# UNITED STATES PATENT AND TRADEMARK OFFICE

10/604,528

<b>Office Action Summary</b>	Application No. 10/604,528	Applicant(s) TSENG, JEN-SHOU	
	Examiner Marina Fishman	Art Unit 2832

## DETAILED ACTION

Gumb discloses a pushbutton for electronic device [Figure 2] comprising:

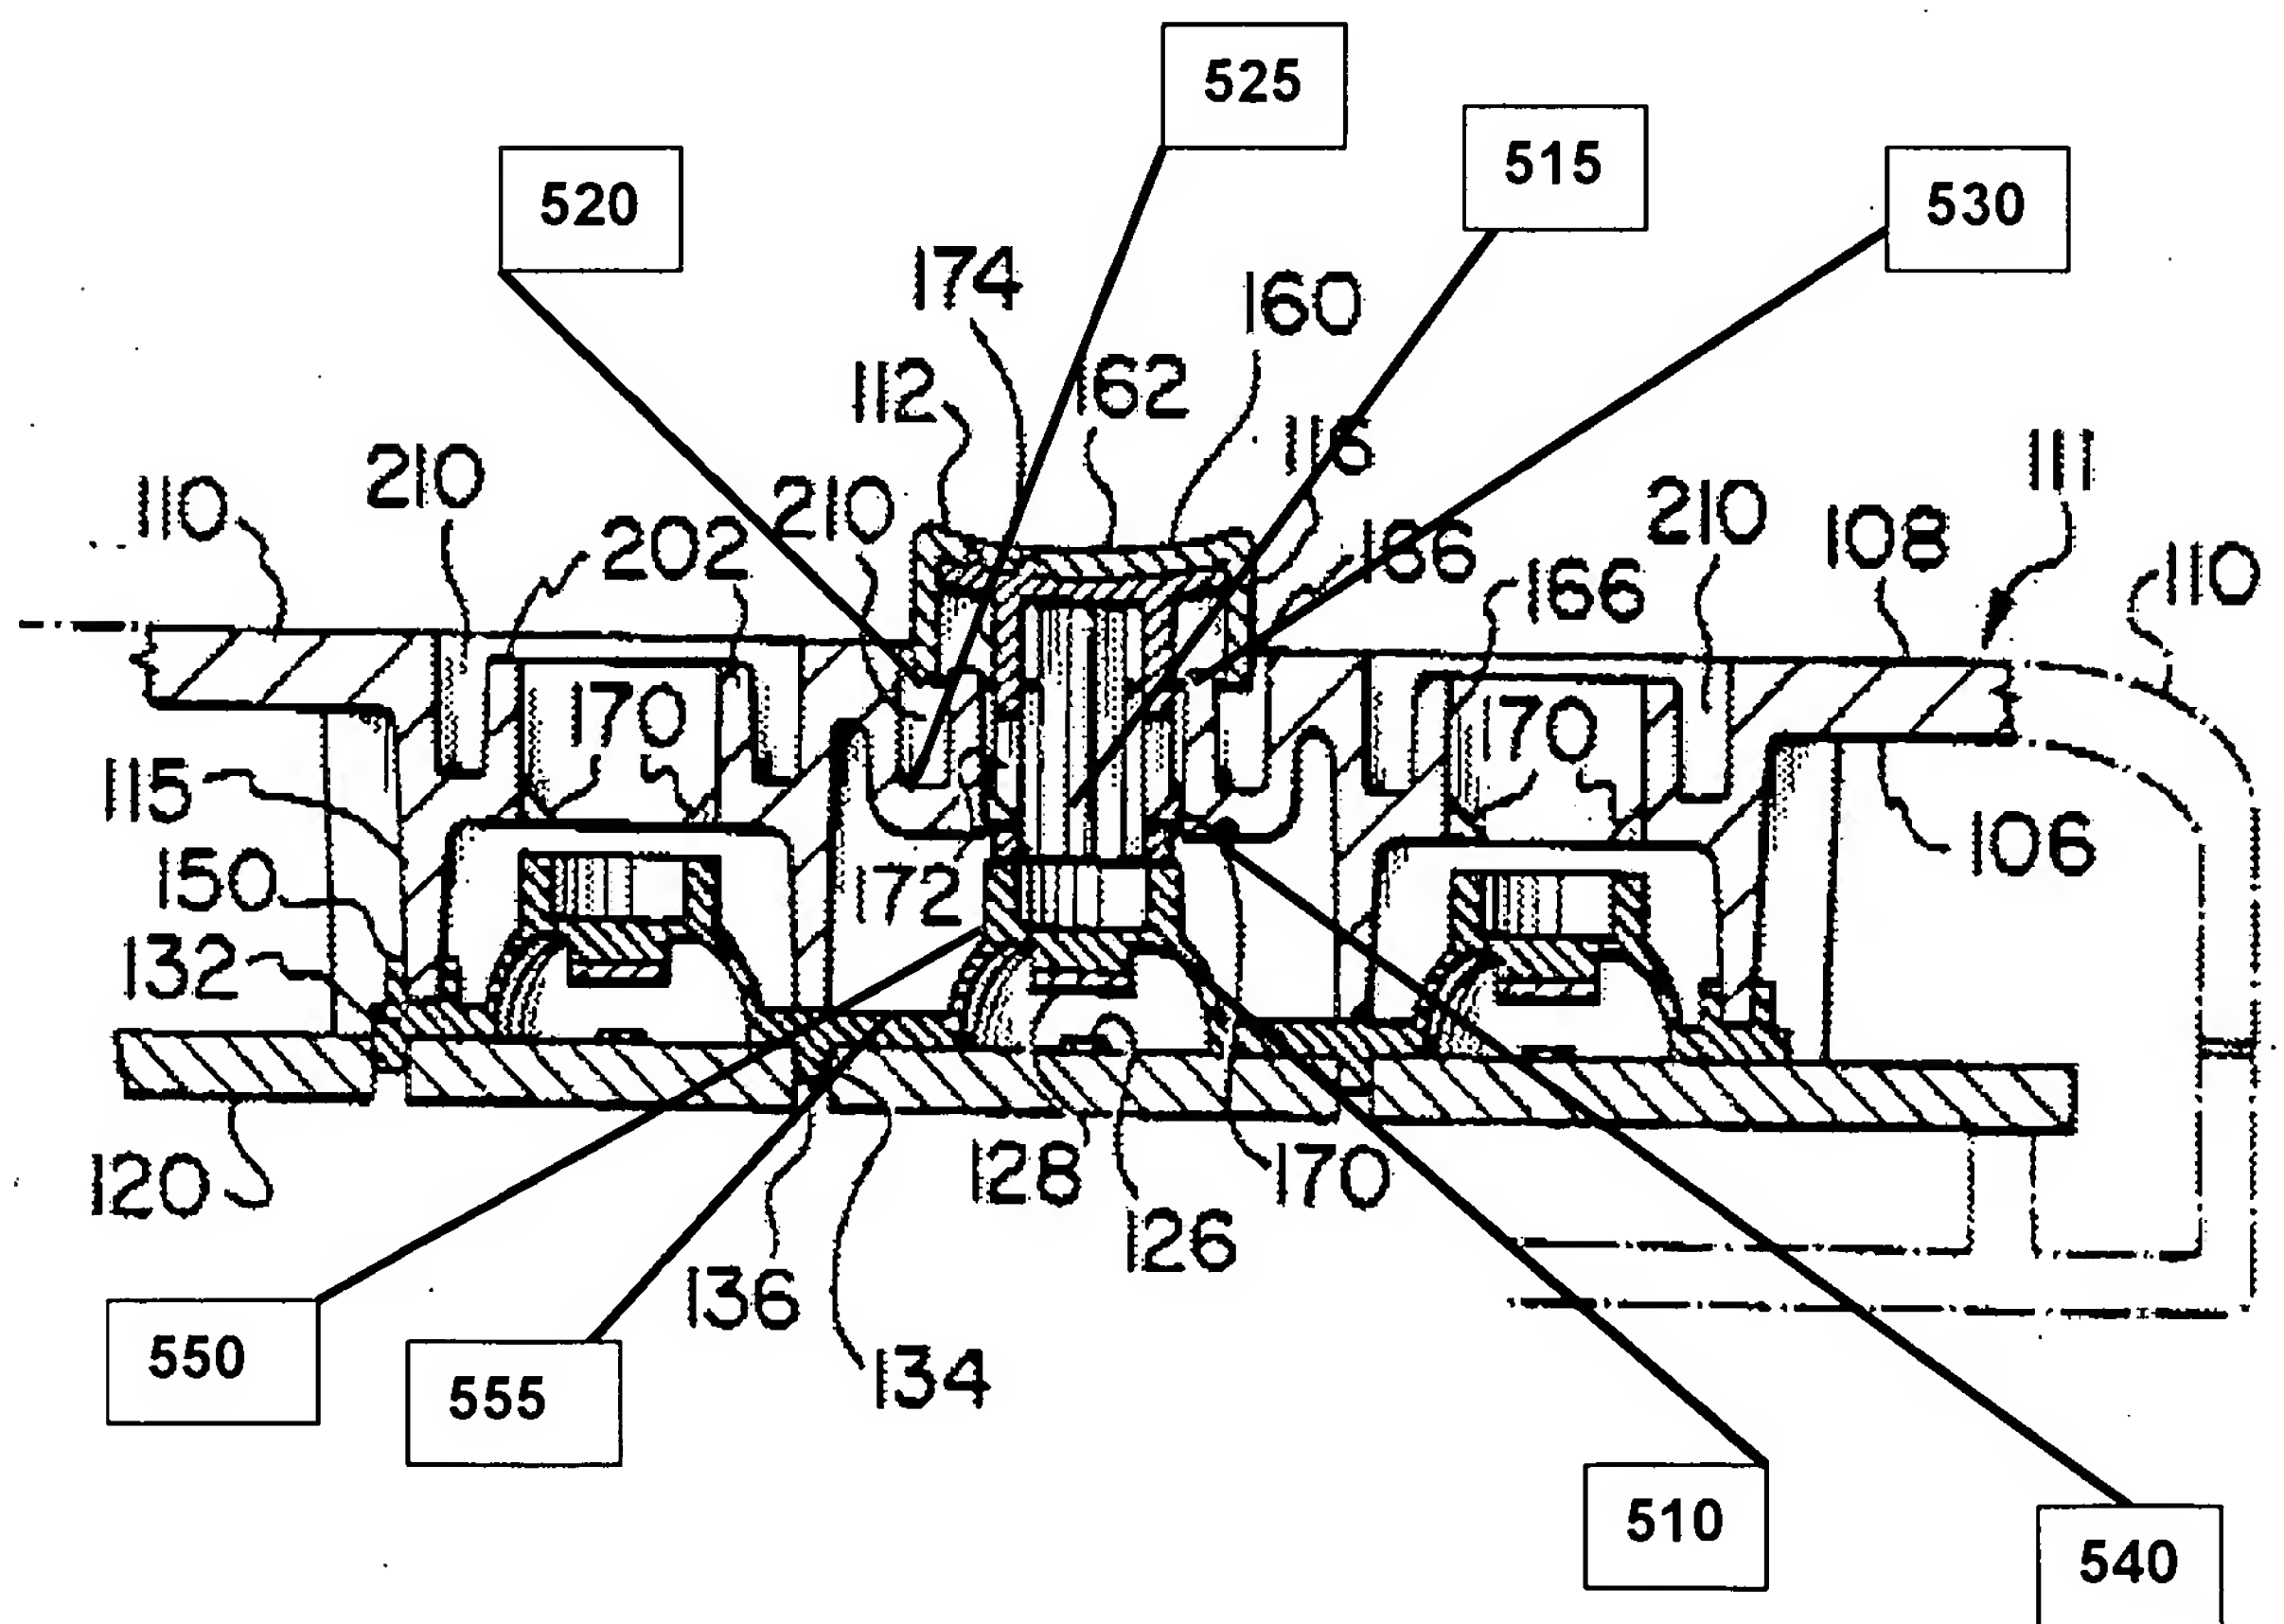
3. Claims rejected under 35 U.S.C. 102(b) as being anticipated by Gumb [US 5,172,805].

- a housing [110];
- a button cover [160];
- a circuit board [120];
- a button body [112], a wing plate [510], a positioning plate [part of 132; Figure 2]; a contact rod [515].

Gumb discloses all the limitations of claimed invention including the dimensional relationship satisfying the equations:

$E - B > D$ ;  $E - D > A$ ;  $D > A$ ;  $A \geq C$ ;  $A \geq B$  and  $C \geq B$ , where:

- the dimension B is height from the bottom of the contact rod

to the contact point on the circuit board [distance between 128 and 126];

- dimension C is height from the bottom of the button body to the outer surface of the housing [distance between 520-525];
- the dimension A [distance between 550 and 555] is height of the wing plate;
- the dimension D is height of the sidewall of button cover next to the button body [dimension between 230 and 240],
- the dimension E is height from the top of the button body [top of 112] to top end [550] of the wing plate.
